Project	IEEE 802.16 Broadband Wireless Access Working Group < http://ieee802.org/16 >	
Title	MRS Handover	
Date Submitted	2007-03-05	
Source(s)	<p>Yousuf Saifullah, Shashikant Maheshwari, Haihong Zheng Nokia 6000 Connection Drive, Irving, TX</p> <p>Sungkyung Kim Sungcheol Chang Chulsik Yoon ETRI 161, Gajeong-dong, Yuseong-Gu, Daejeon, 305-350, Korea</p> <p>Hyunjeong Kang, Sungjin Lee, Hyoung Kyu Lim and Jungje Son Samsung Electronics</p> <p>Aik Chindapol Siemens Corporate Research 755 College Road East, Princeton, NJ</p>	<p>Voice: 972 894 5000 Fax: Yousuf.saifullah@nokia.com, shashikant.maheshwari@nokia.com, haihong.l.zheng@nokia.com</p> <p>cyrano@etri.re.kr</p> <p>hyunjeong.kang@samsung.com</p> <p>Voice: + 1 609 734 3364 Email: aik.chindapol@siemens.com</p>
Re:	This is a response to the call for proposals 80216j-07_007r2.pdf	
Abstract	This contribution proposes Mobile RS handover procedure.	
Purpose	Add proposed spec changes in P802.16j Baseline Document (IEEE 802.16j-06/026r2)

MRS Handover

Figure 1: MRS Handover

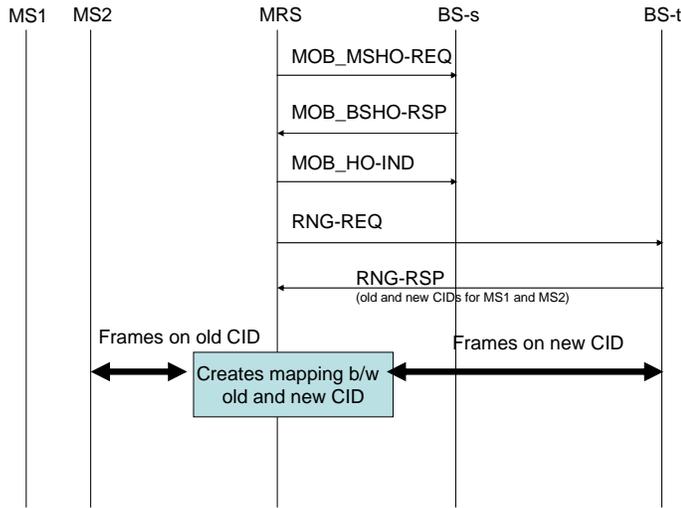
1. MRS sends MOB_MSHO-REQ message to the serving MR-BS on its basic CID for initiating handover.
2. The serving MR-BS sends MOB_BSHO-RSP message to the MRS. The serving MR-BS sends the MAC addresses, SFIDs and CIDs of the MSs under MRS to the target MR-BS over the backbone. It receives HO_ID and sends HO_ID in the MOB_BSHO-RSP message.

3. The MRS sends MOB_HO-IND message to the serving MR-BS.
4. The MRS performs network re-entry by sending RNG-REQ containing HO_ID. If the MRS shares a security association with the target BS, it sends HMAC/CMAC in the message. The MRS may not be able to receive HO_ID from the serving BS, if the MOB_BSHO-RSP message is not received by the MRS. The MRS sends the serving BS ID to the target BS. The target MR-BS uses the serving BS ID to contact the serving BS and retrieves the MAC addresses and CIDs of the MSs using backbone procedures.

5. The BS may assign new CIDs for MS1 and MS2, and sends it to MRS in RNG-RSP. If new CIDs are assigned, then MRS shall create mapping between old and new CID for each MS. It swaps them for UL/DL traffic and signaling. In this way no signaling procedure is initiated for MS1 and MS2.

During swapping of CID in the MPDU header, MRS may also need to recalculate and replace CRC, which is a minor calculation. CMAC digest is calculated using CID. The MR-BS calculates CMAC on the old CID. Figure 1 shows RS initiated handover. An MR-BS initiated HO for MRS is similar to the MRS initiated HO.
